Stormwater Facility Name: Pond A2

Facility Location & Jurisdiction: Overlook Filing No. 1- El Paso County

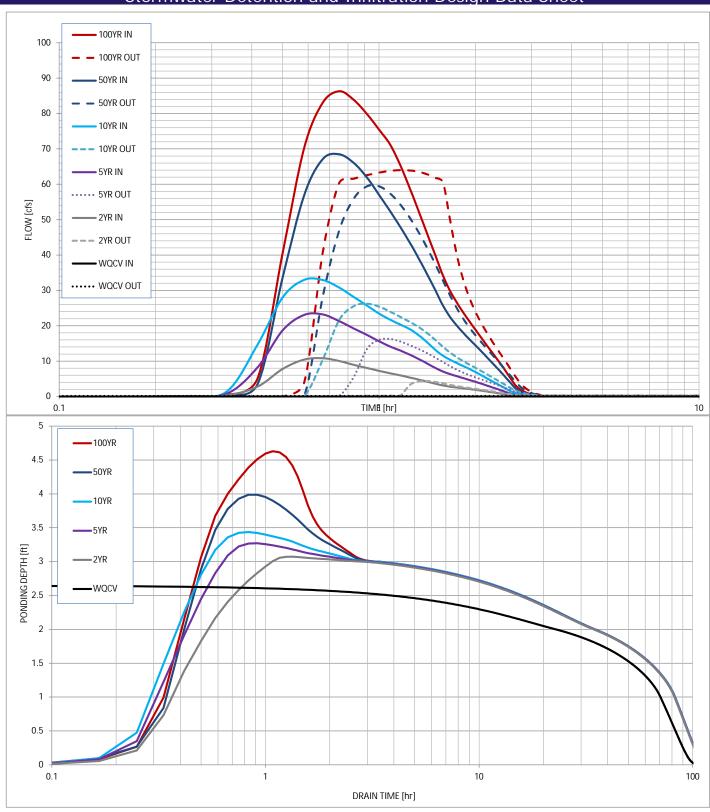
These don't match the MHFD spreadsheet in the drainage report.

These drain times are signficantly different than what is reported in the drainage report. See comments there
